Environmental Impact Statement

ERATTA NO. 01

N4 Collooney to Castlebaldwin Proposed Road Development

Figure No.: Fig.: 15.2.2
Sheet 2 of 8

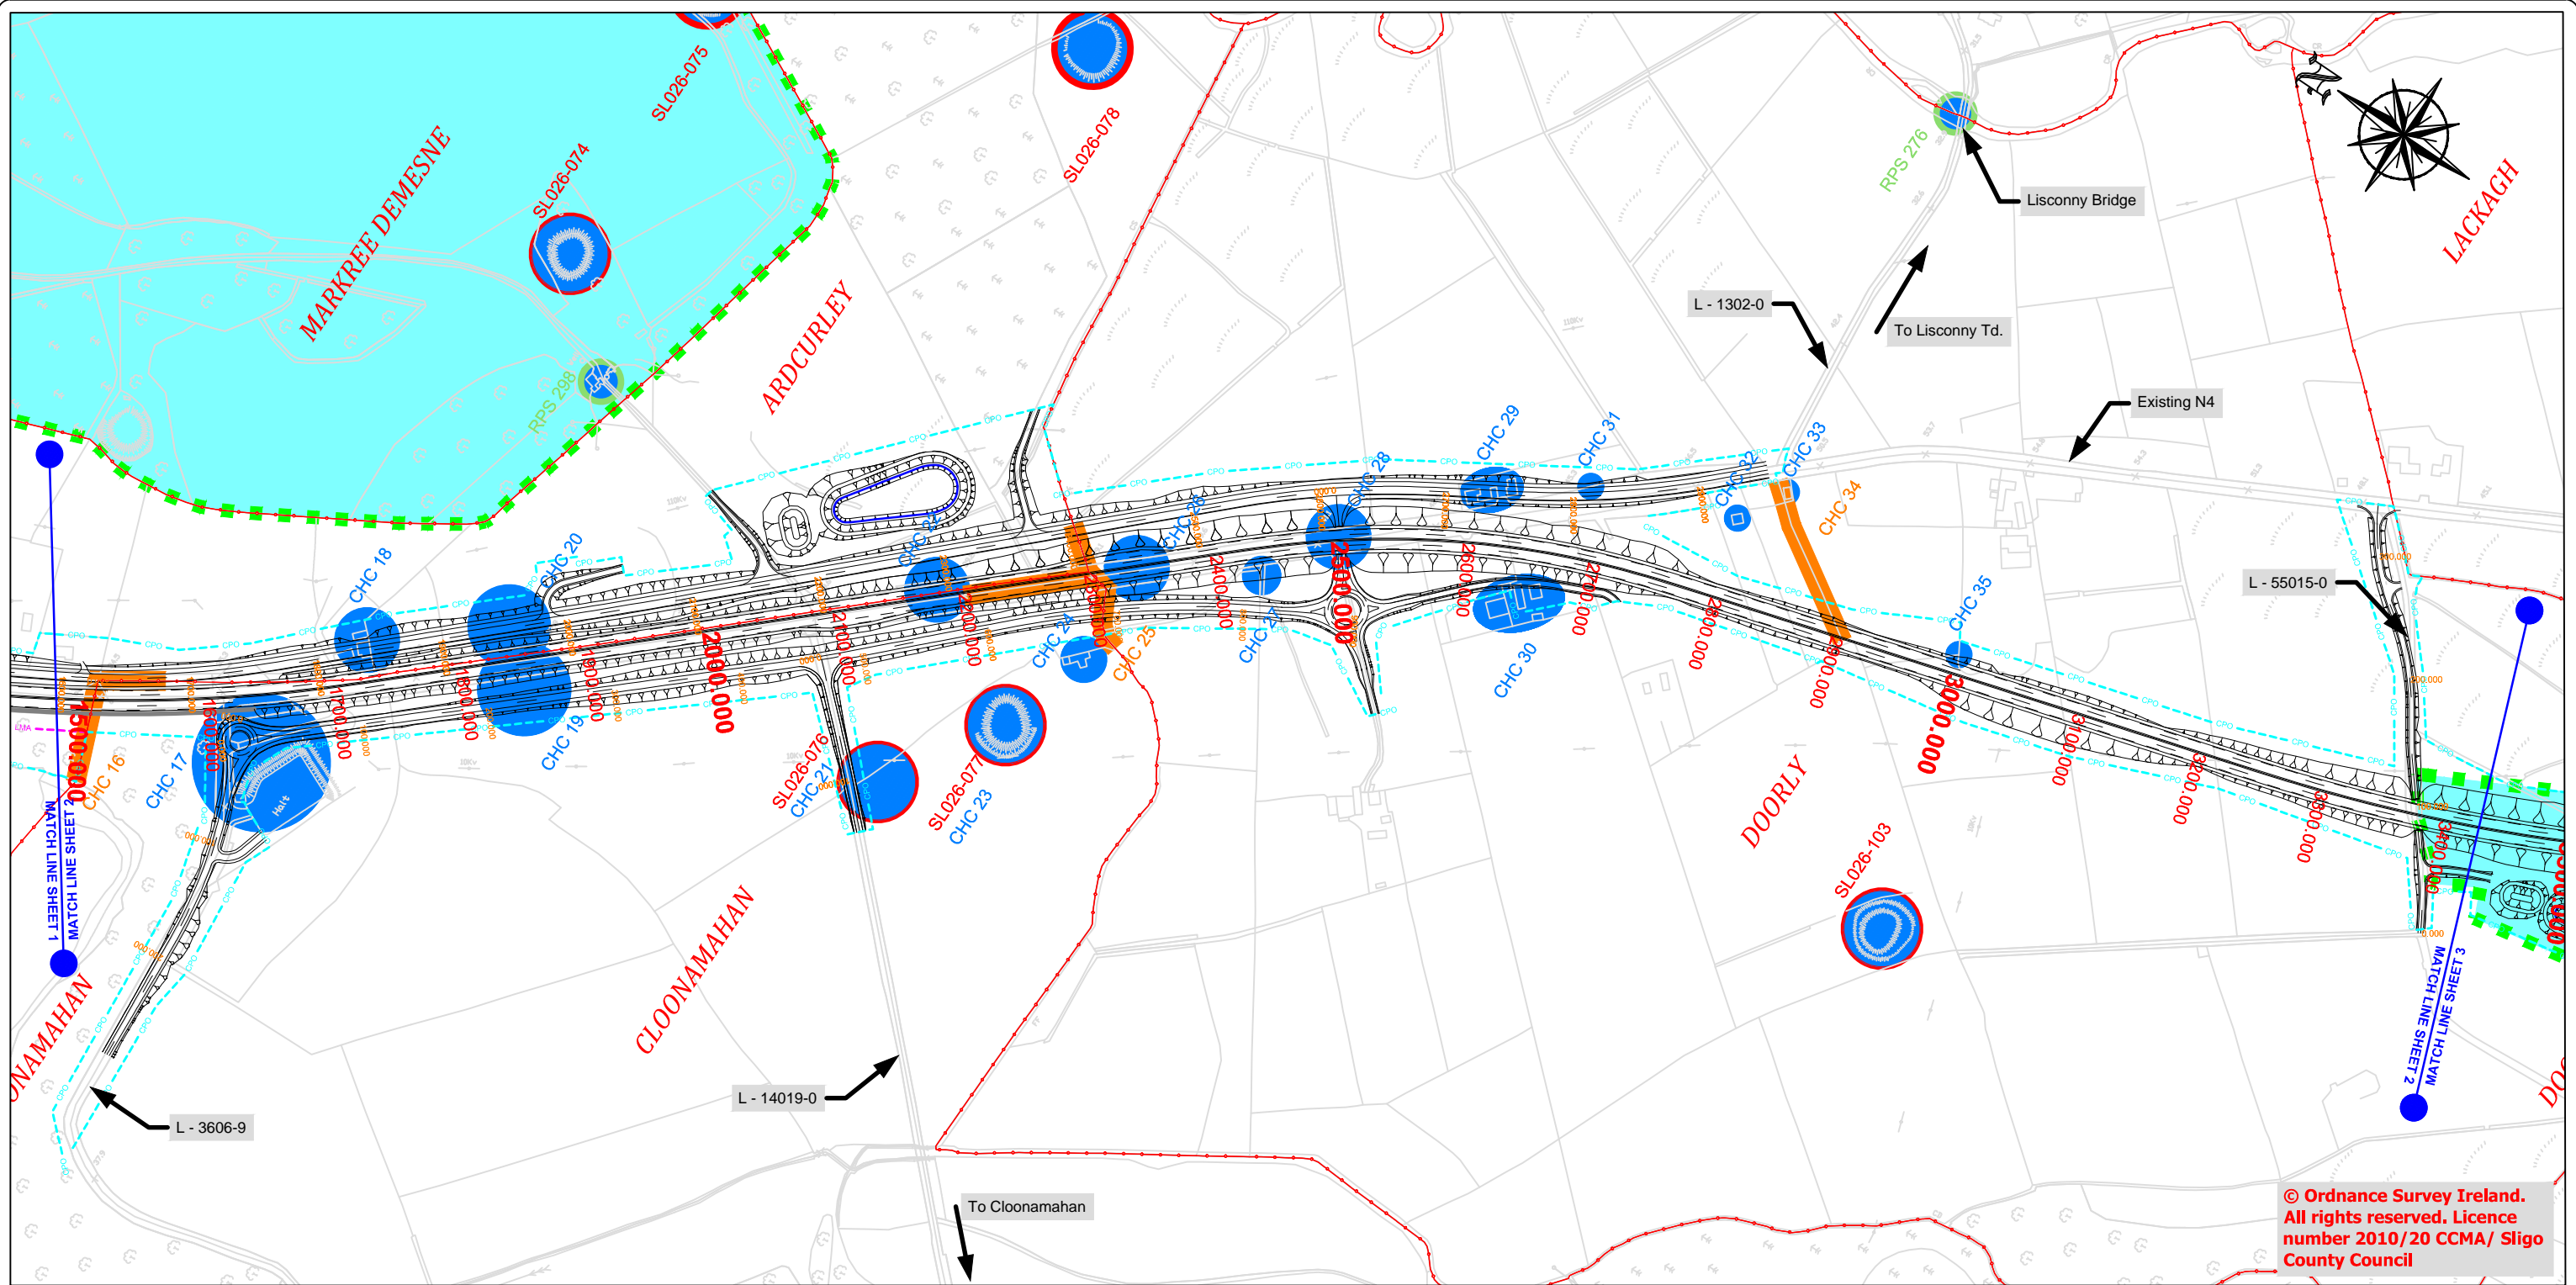
Figure 15.2.2

This map corrects printing errors in relation to the location of R298. The location which was originally based on NIAH coordinates has been extended to fully cover the gate lodge.

Date	By	Revision
April 2014	FM	This is an errata to the EIS as described in Errata Sheet No. 01.
		The circle depicting the RPS number (298) for the Gate Lodge has been modified to fully encompass the Gate Lodge.
